Economic Commission for Europe**Inland Transport Committee****World Forum for Harmonization of Vehicle Regulations****Working Party on Noise and Tyres****Seventy-ninth session**

Tyres: UN Regulations on retreaded tyres**Proposal for the 01 series of amendments to UN Regulation
No. 108****Submitted by the small working group on retreaded tyres***

The text reproduced below was prepared by the experts from the small working group on retreaded tyres with the aim to move the prescriptions for snow grip performance of retreaded tyres from UN Regulation No. 108 to a new dedicated UN Regulation on type approval of retreaded tyres of classes C1, C2 and C3 with respect to their snow grip performance and/or classification as traction tyre. The modifications to the current text of the UN Regulation are marked in bold for new or strikethrough for deleted characters.

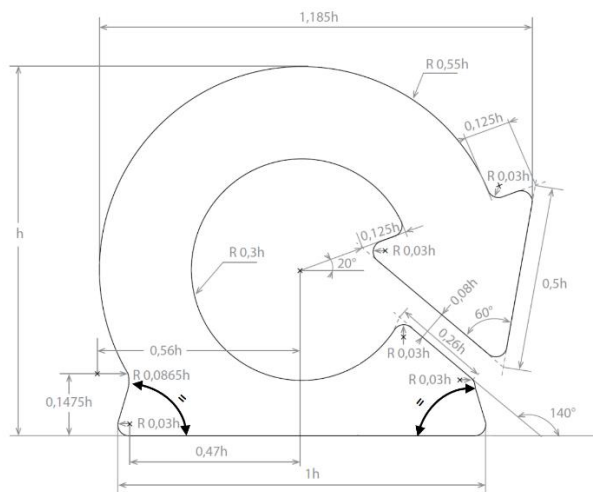
Add new paragraphs 3.2.11. and 3.2.12. to read:

"3.2.11. The symbol below if the tyre is an EMT, where "h" is at least 12 mm.

Annex 2

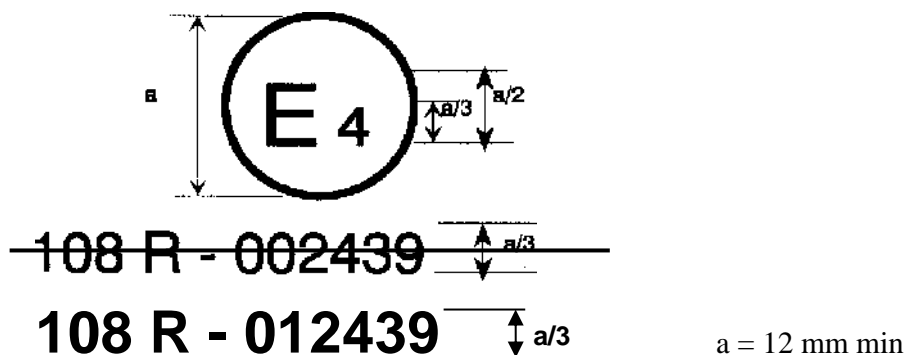
"Annex 2, amend to read:

The above approval mark affixed to a retreaded tyre shows that the retreading production unit concerned has been approved in the Netherlands (E4) under approval number 108R0012439, meeting the requirements of **01 series of amendments** to this Regulation ~~in its original form (00)~~.

The approval number must be placed close to the circle and either above or below the "E" or left or right of that letter. The digits of the approval number must be on the same side of the "E" and face in the same direction. The use of Roman numerals as approval numbers should be avoided so as to prevent any confusion with other symbols. "

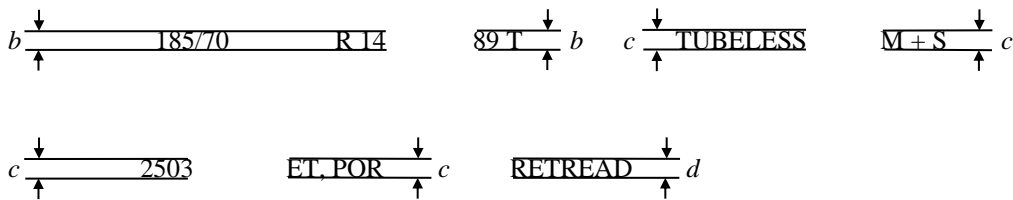
Annex 3, paragraph 1, amend to read:

"1. Example of the markings to be borne by retreaded tyres placed on the market after the entry into force of this Regulation
